SUBJECT: ORDER FOR MODIFICATION OF LICENSE CONCERNING PRIMARY COOLANT
SYSTEM PRESSURE ISOLATION VALVES

In the Matter of
Wisconsin Public Service
Corporation Et Al.
(Kewaunee Nuclear Power
Plant)

ORDER FOR MODIFICATION OF LICENSE

SAFETY EVALUATION REPORT
KEWAUNEE NUCLEAR POWER PLANT
PRIMARY COOLANT SYSTEM PRESSURE ISOLATION VALVES
(WASH-1400, EVENT V)

Figure 1. Valve Configurations Designated by the NRC To Be Included in This Technical Evaluation

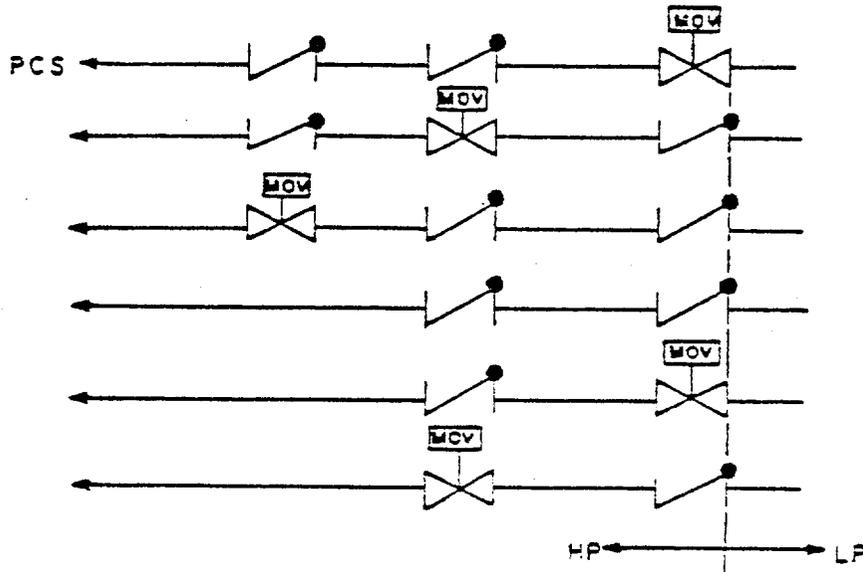
- 1) The high-pressure system must be connected to the Primary Coolant System;
- 2) there must be a high-pressure/low-pressure interface present in the line;
- 3) this same piping must eventually lead outside containment;
- 4) the line must have one of the valve configurations shown in Figure 1; and
- 5) the pipe line must have a diameter greater than 1 inch.

It has been determined that the Residual Heat Removal/Low-Head Safety Injection system in Kewaunee Unit 1, incorporates valving in one of the configurations (identified in Figure 1) designated by the NRC as a valve configuration of concern. Moreover, based on the previously docketed information and drawings made available for FRC review, FRC found that the crossover line between the Loop B cold-leg Accumulator and the Residual Heat Removal/Low-Head Safety Injection Systems lines also incorporates a valve configuration of concern. Thus, if the licensee's review of the valving configuration contained in this crossover line confirms FRC's finding, then valve configurations of concern exist in two systems of Kewaunee Unit 1 and incorporate the valves listed in Table 1.0.

If WPS modifies the Plant Technical Specifications for Kewaunee Unit 1 to incorporate periodic testing (as delineated in Section 2.2) for the check valves itemized in Table 1.0, then FRC considers this an acceptable means of achieving plant compliance with the NRC staff objectives of Reference 1.
